**Responses to NRC Request for Additional Information for Westinghouse Electric
Company Topical Report WCAP-17794-P/WCAP-17794-NP, Revision 0, “10x10
SVEA Fuel Critical Power Experiments and New CPR Correlation: D5 for
SVEA-96 Optima3” (Non-Proprietary)**

August 2016

Figure 19-1 - Comparison of I_2 integral with Boiling Length (BL) and Annular Length (AL)

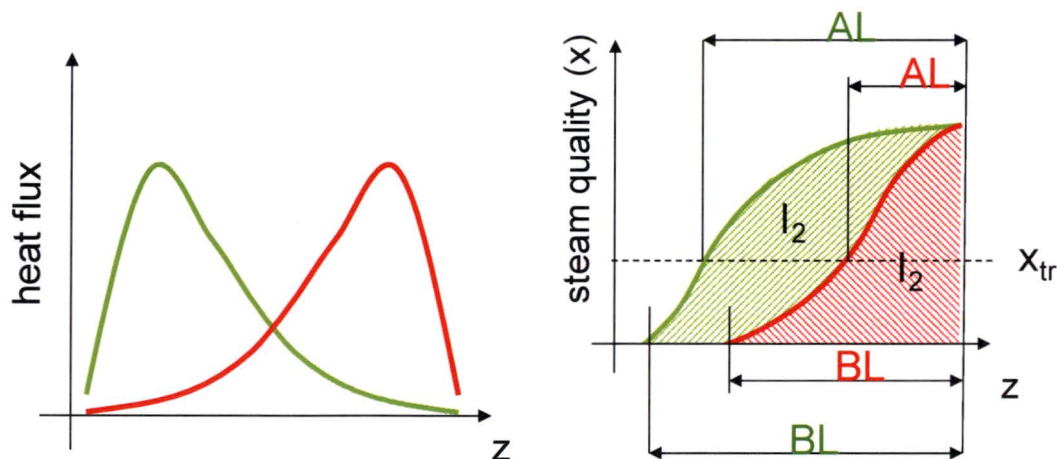
Numerous correlations of both quality/heat flux and quality/boiling length type have been developed, sometimes showing excellent agreement with extensive collections of experimental data. As long as complex parameters such as axial power distribution or geometry do not vary significantly, correlating the dryout power reduces to a regression problem in 3-4 dimensions depending on which parameters are included. Given enough experimental data, a solution to such a problem can be found with little consideration of the underlying physics. In fact it can be shown that, assuming uniform power distribution, the quality/heat flux, quality/boiling length and I_2 concepts are all fully equivalent.

A comparison of the I_2 integral used in the D5 CPR correlation for SVEA-96 Optima3 fuel with the boiling length and annular length parameters used, e.g., in the CPR correlation for SVEA-96 Optima2 fuel is presented in the right panel of Figure 19-1 for two different axial power distributions shown schematically in the left panel. Since boiling length and annular length each sample only one cross-over point on the quality curve, these parameters are very sensitive to how quickly the power increases in the lowest part (first few nodes) of the bundle, but they are insensitive to the distribution of power above those points. In contrast, the I_2 parameter integrates the entire distribution of quality (area under quality curve) which gives a more robust behavior. This is particularly relevant for application to transients where sudden disturbances in local mass flow and power may occur near the inlet.

Figure 28-1 - D5 R-factor as a function of burnup

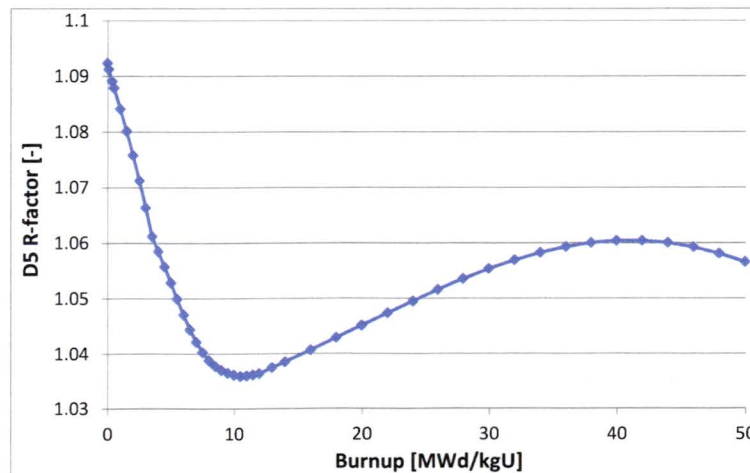
[

- (b-c) In addition, this answer addresses similar sparse regions for R-factor [$J^{a,c}$ in the plots of R-factor versus pressure and inlet subcooling provided in response to RAI-SNPB-03.

The sparse regions are characterized by off-nominal conditions in mass flux, pressure or inlet subcooling, combined with an R-factor [$J^{a,c}$. As explained in the response to RAI-SNPB-07, the relevant radial power distributions for a dryout limiting assembly are those accomplished by the nuclear design optimization, attempting to obtain a flat rod-wise CPR distribution in the un-controlled condition at the end of Gd depletion when the fuel reaches its maximum reactivity (k_{inf}). This is equivalent to minimizing the R-factor at the time of maximum reactivity. The example below shows such an optimized R-factor as a function of burnup for a case where maximum reactivity is reached around 10 MWd/kgU. The example confirms that the R-factor range below 1.06 is the relevant range for use of the D5 correlation to predict CPR margins for limiting assemblies in the core.

- (d) Conditions of high R-factor are generally not limiting, as explained in the response to RAI-SNPB-07. The equivalence between optimizing nuclear design to achieve a flat rod CPR distribution, and minimizing the R-factor when the fuel is limiting, is given in the previous paragraph (b-c).
